FID1
Fiducial 40 MilFID2
Fiducial 40 MilFID3
Fiducial 40 MilFID4
Fiducial 40 MilFID5
Fiducial 40 MilFID6
Fiducial 40 MilTitle: **RPILink**Part #: **GDL-ADRPILINK-A**

Revision: A

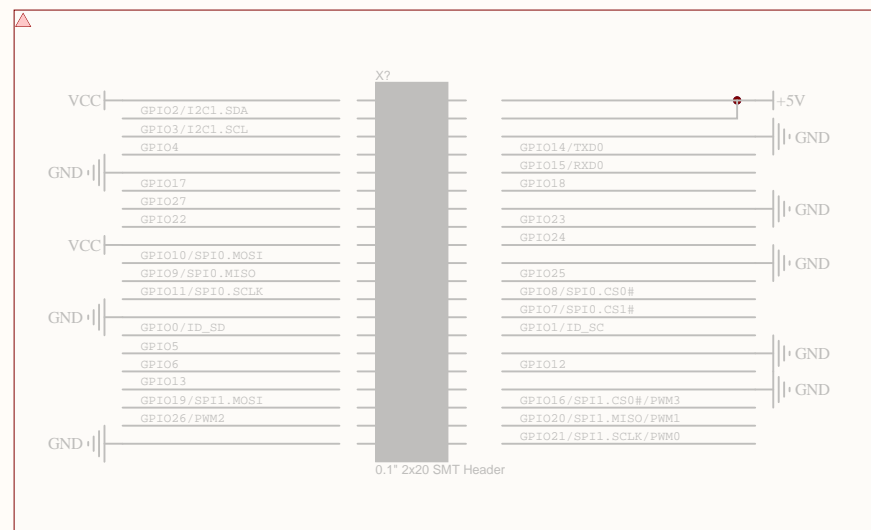
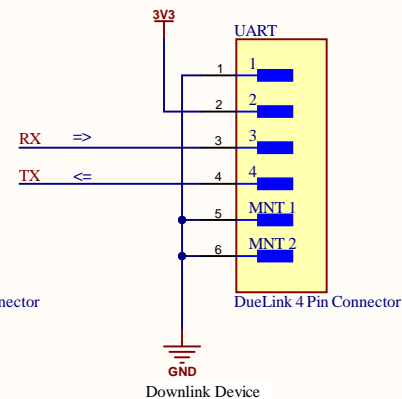
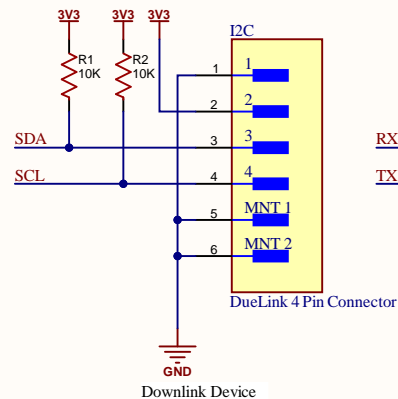
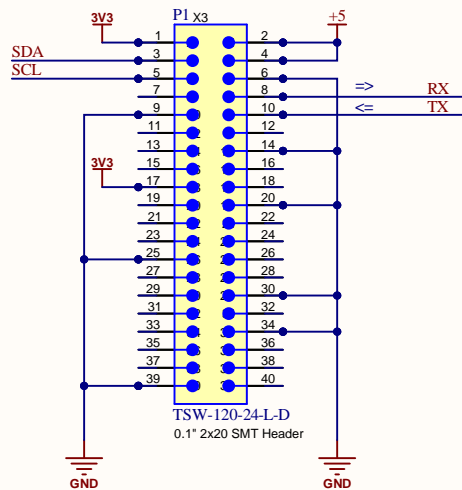
There are 2 overlapping connectors here!

The pins are mirrored as the SMT connector goes on the bottom. Pin 1 is pin 2 for example.

The overlapping TH header is correct.
